**CALIFORNIA COASTAL COMMISSION**

**STAFF REPORT: PERMIT AMENDMENT**

**APPLICATION NUMBER:** 5-98-156-A1

Modify the previously approved 70-foot high parking structure to expand the building footprint over Chestnut Place and to increase the number of parking stalls from 1,550 to approximately 2,195.

EXHIBIT # 3  
 PAGE 1 OF 1

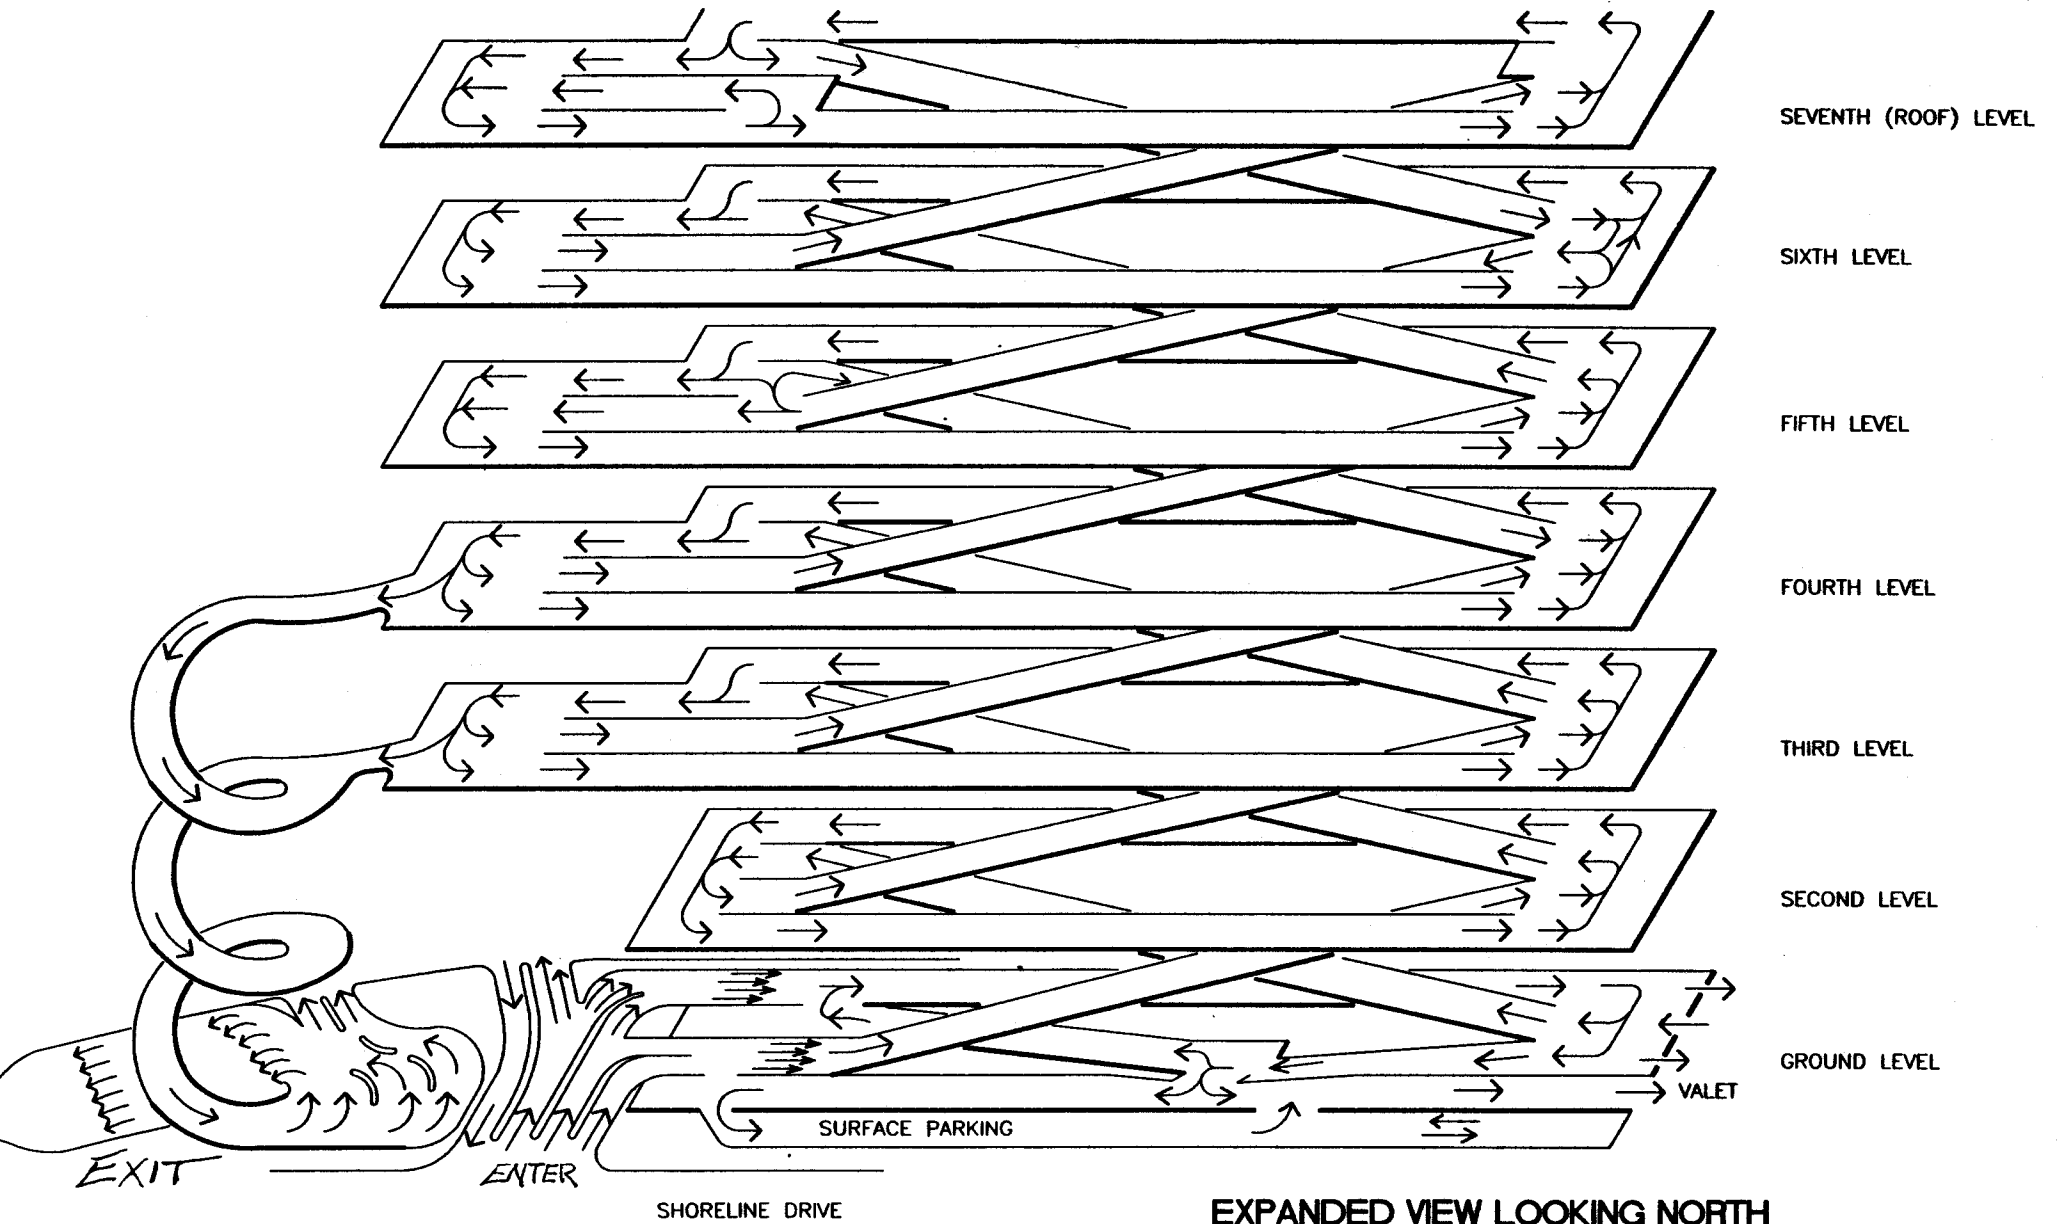
The proposed parking structure plan includes a vehicular passage through the proposed parking structure on the Chestnut Place right-of-way, but does not include a sidewalk for pedestrians (Exhibit #3). A bicycle route is proposed to bypass the structure around its north and east sides to connect the existing Chestnut Place bike path to the Regional Bicycle Route that currently passes along the south side of the project site next to Shoreline Drive (Exhibit #3).

Therefore, in order to protect the public's ability access the coast, the applicants shall submit revised plans that provide a continuous public sidewalk along Chestnut Place. The certified LCP calls for a ten-foot wide sidewalk along Chestnut Place including a parkway. The passage of Chestnut Place through the proposed parking structure, however, would make it difficult to landscape because the structure would block the direct sunlight. In addition, the width of the proposed Chestnut Place passage through the parking structure is limited by support columns and vehicular lanes. Therefore, the Commission will not require the provision of a parkway along Chestnut Place where the proposed parking structure would cover it and block out the sunlight. The applicants are required, however, to provide and maintain a minimum six-foot wide sidewalk for public pedestrian access through the proposed parking structure on the west side of the Chestnut Place right-of-way.

In addition, the applicants shall provide the proposed bicycle route along the north and west sides of the proposed structure, and shall not interfere with the existing Regional Bicycle Route along the Shoreline Drive frontage. Only as conditioned can the proposed amendment be found to be consistent with the public access policies of the Coastal Act.

Prior to issuance of the coastal development permit, the applicants shall submit for the review and approval of the Executive Director, revised plans that provide a minimum six-foot wide sidewalk for public pedestrian access through the proposed parking structure on the west side of the Chestnut Place right-of-way. In addition, the applicants shall provide and maintain the bicycle path proposed along the north and west sides of the proposed parking structure that would connect the existing Chestnut Place bike path to the existing Regional Bicycle Route on the south side of the proposed parking structure (north side of Shoreline Drive). The applicants shall not interfere with public use of the existing Regional Bicycle Route that runs along the north side of Shoreline Drive, the Chestnut Place sidewalk required by this condition, or the proposed bicycle path connecting the Chestnut Place bike path to the Regional Bicycle Route. The development shall be maintained consistent with the plans approved by the Executive Director.

EXHIBIT # 5  
PAGE 1 OF 2

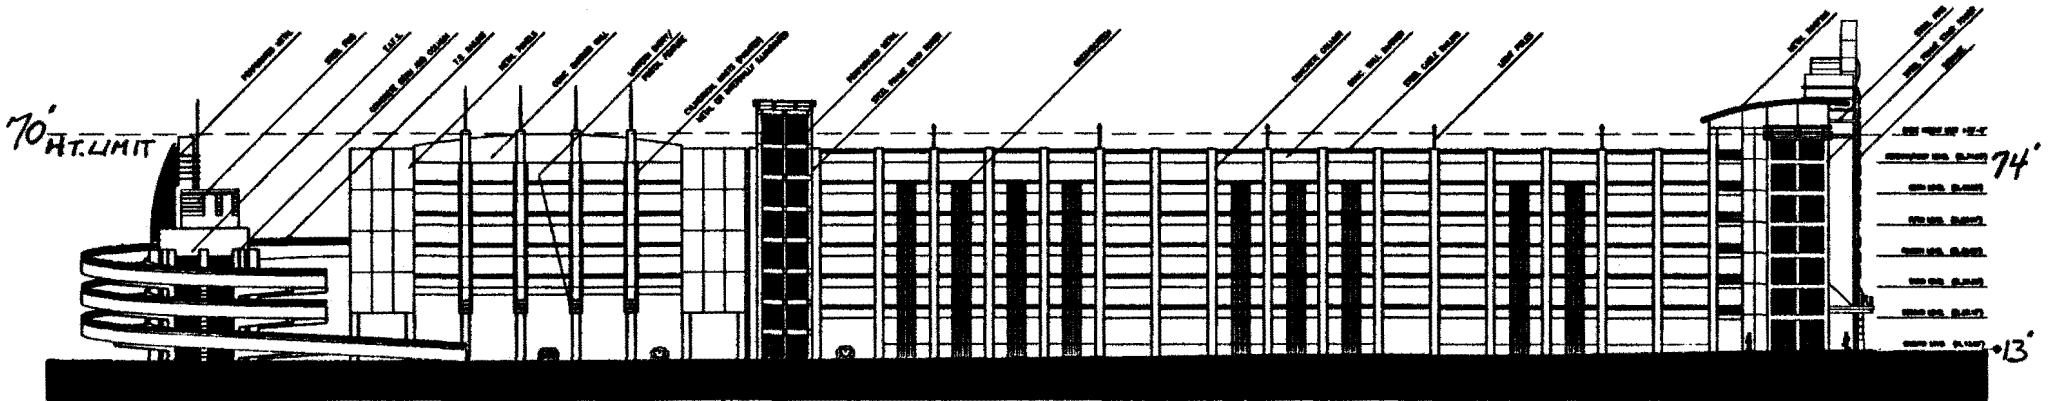
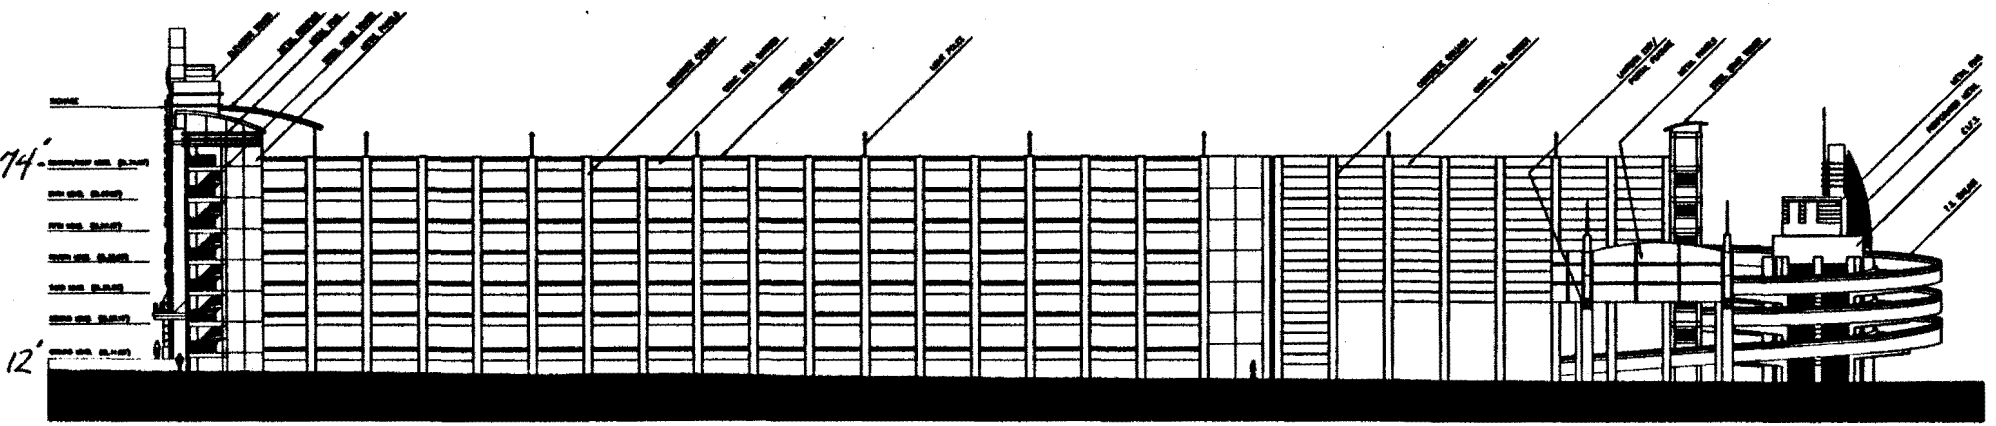
The roof and bulk of the currently proposed structure is at or below 70 feet above the flood plain elevation. An architectural extension, however, extends to approximately 100 feet above the flood plain elevation. Elevator housings are proposed to extend to approximately 90 feet above the flood plain elevation (Exhibit #5).

The certified LCP states that the parking structure proposed on this site has a height limit of 70 feet above the flood plain elevation (13.8' MLLW). The certified LCP, however, allows architectural features to exceed the 70-foot height limit "if they do not contain any usable interior space and do not significantly add to the mass of the structure or negatively affect public views".

The proposed 100-foot tower is an architectural feature designed to enhance the visual effect of the proposed structure and does not contain any usable interior space or significantly add to the mass of the structure. The proposed elevator housings also do not contain any usable interior space or significantly add to the mass of the structure. Therefore, the design of the proposed structure can be found to be consistent with the height limits of the certified LCP and the visual resource policies of the Coastal Act.
